**ROCKY MOUNTAIN ARSENAL**

FINAL  
TECHNICAL PLAN  
VERSION 3.1

TASK NO. 10  
SEWERS AND PROCESS WATER SYSTEM INVESTIGATIONS

TASK NO. 10  
SEWERS AND PROCESS WATER SYSTEM INVESTIGATIONS

**FIGURE 3**  
**Investigative Program South Plants**  
**Process Water Return System**  
Rocky Mountain Arsenal, Task 10  
Prepared by Ebasco Services Incorporated

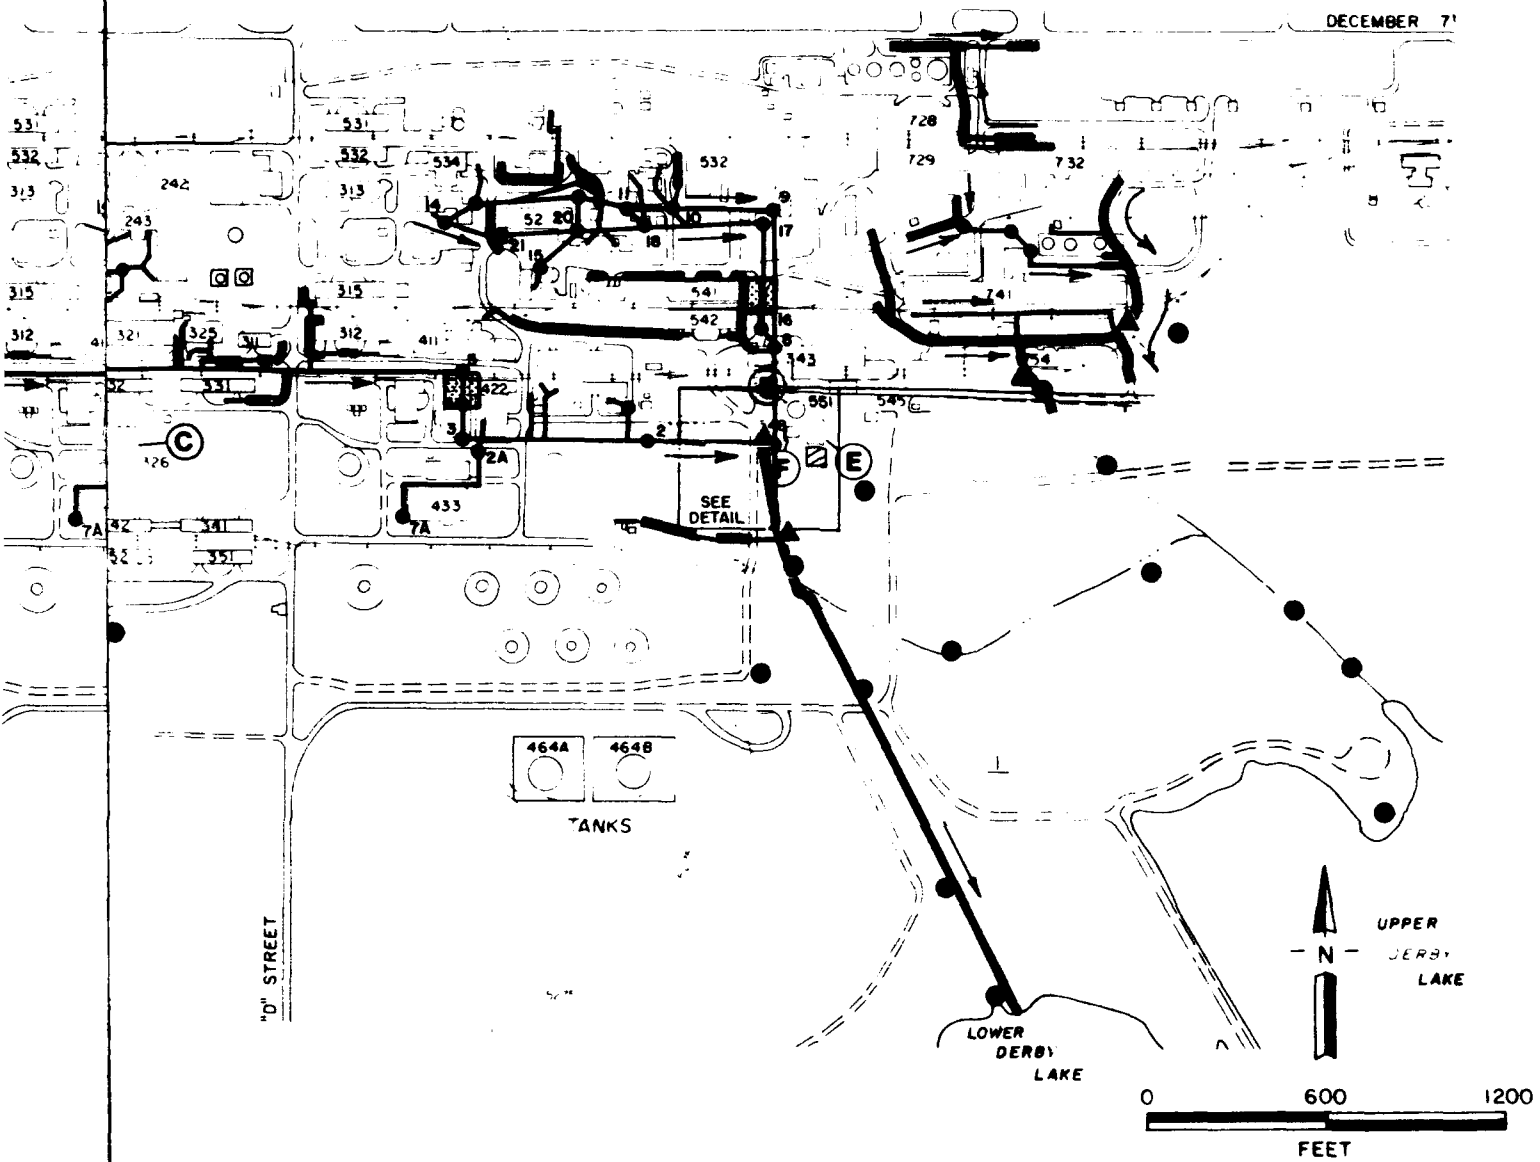
4. Comment: The proposed revision states that "after all 'worst case' situations (areas where past and present leaks overlap) have been identified during steps 1 and 2, a soil boring program will then be initiated to identify soil contamination in the areas of past and present leaks". Yet Figure 3 shows proposed boring locations for Task 10. How have these locations been determined before steps 1 and 2 have been completed?

Response: The proposed boring locations shown on Figure 3 are for the process water return system discharge points to the return ditches. These locations were chosen because these canals have, at some time, been used for returning used cooling water to the lakes storage system for recirculation. The borings to be chosen "after all 'worst cases' situations have been identified" are for the process water distribution system lines in the South Plants area.
